UTAH DIVISION OF OIL, GAS AND MINING FACSIMILE TRANSMISSION COVER SHEET

Re: NOV N92-39-7-1, Refuse Ditch CGDR-3A-CGD-7 (lower), AMAX Coal West Inc., Castle Gate Mine, ACT/007/004, Folder #2, Carbon County, Utah

September 10, 1993

BORING NO.	SAMPLE NO.	DEPTH IN FEET	PL	LL	PI	NAT. WC	SOIL DESCRIPTION	CRAWFORD ENVIRONMENTAL <small>GEOTECHNICAL ENVIRONMENTAL ENGINEERING SERVICES</small>	
							CGRD3 #2 - Past Rip Rap Placement.	GRADATION ANALYSIS	
								DRAWN BY: PTP	JOB NO. 342047
								DATE: 9/8	PLATE

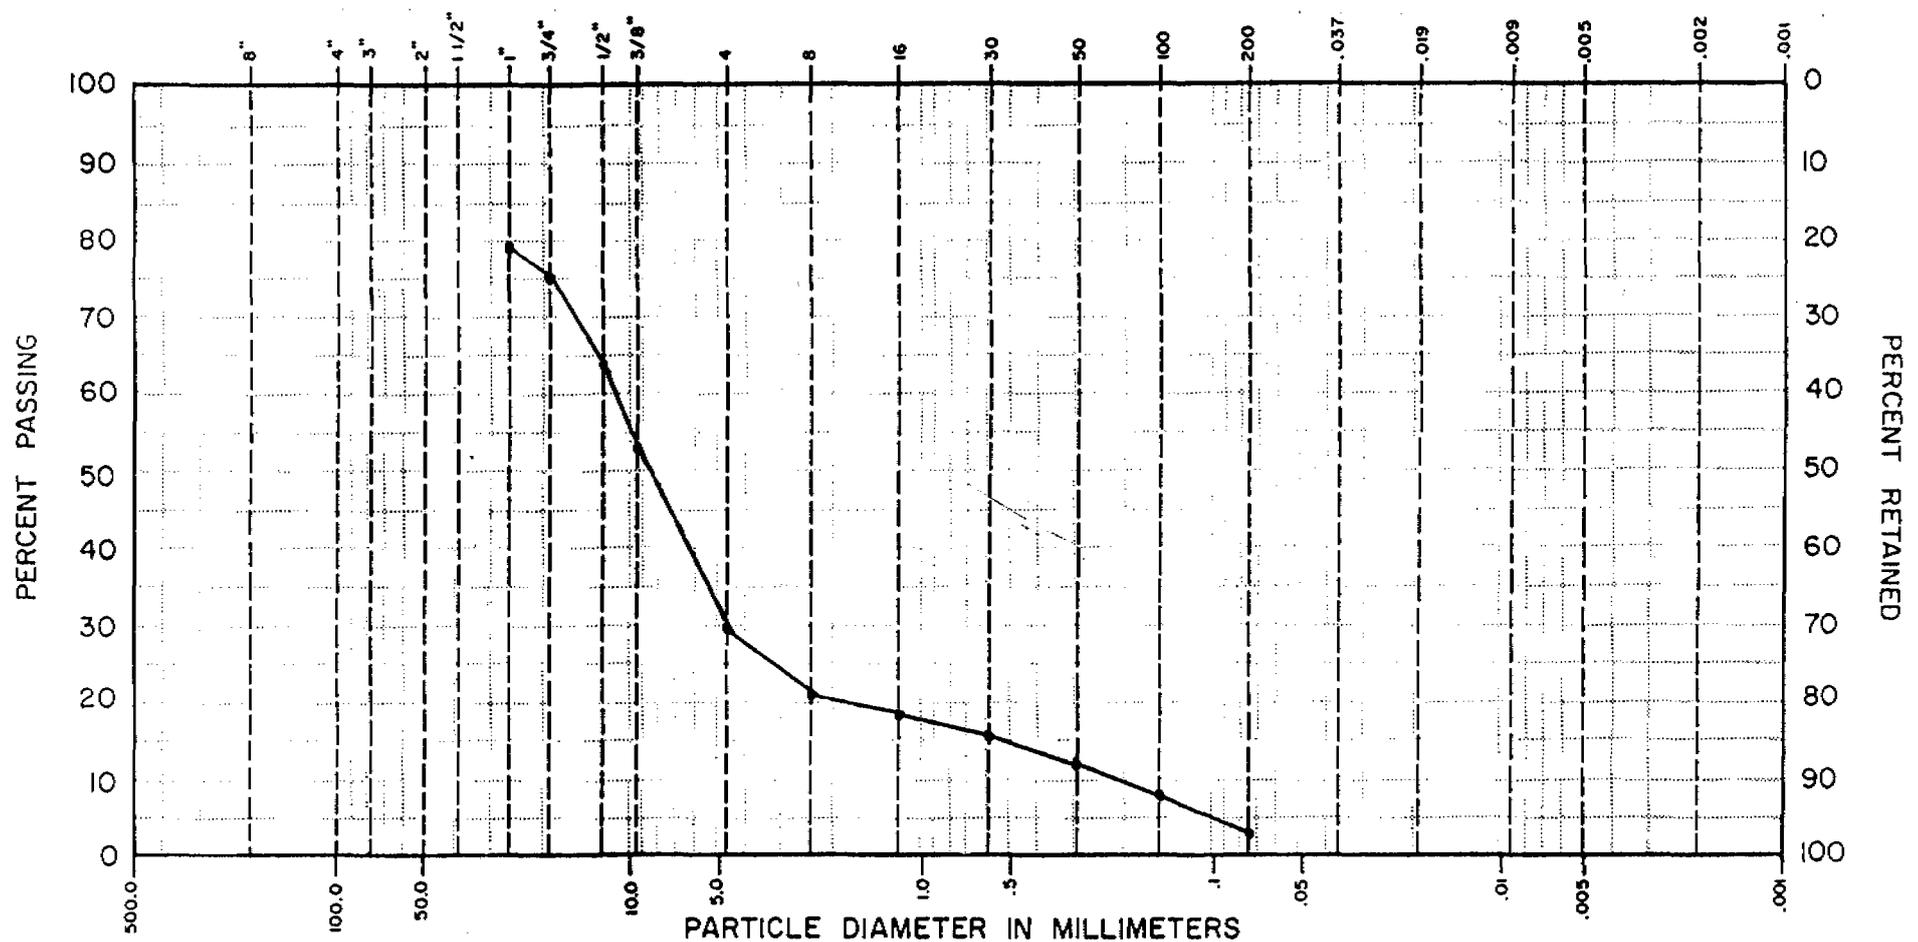
1. The depth and grading of riprap. The riprap appeared to be lacking in the finer grade of materials and contained many voids between the larger rock. Clean angular small fraction material may be needed to fill these voids. Information gathered to determine the grade of the riprap is being analyzed.
2. The gravel filter blanket did not appear to meet sizing criteria. The first sample the Division obtained, prior to riprap placement, was too finely graded. A second gravel sample was obtained following riprap placement and will be used to determine the adequacy of gradation. The filter blanket material used was rounded river rock and sand; not, crushed angular rock.

The second paragraph relates to the filter blanket. The contractor did have a gradation problem with the upper third of the ditch. I took a sample on August 26 and it did not meet the gradation standard. The contractor added more course material to the blanket on August 27. I again sampled the blanket and lab results showed that the blanket was within the specification. I also had the contractor remove riprap approximately 100 feet upstream from the bottom of the ditch to verify its adequacy. This is the same location where you took your samples. The lab report showed that it was acceptable filter blanket material. Your statement that river rock and sand was used is correct. However, is no requirement to use crushed angular material.
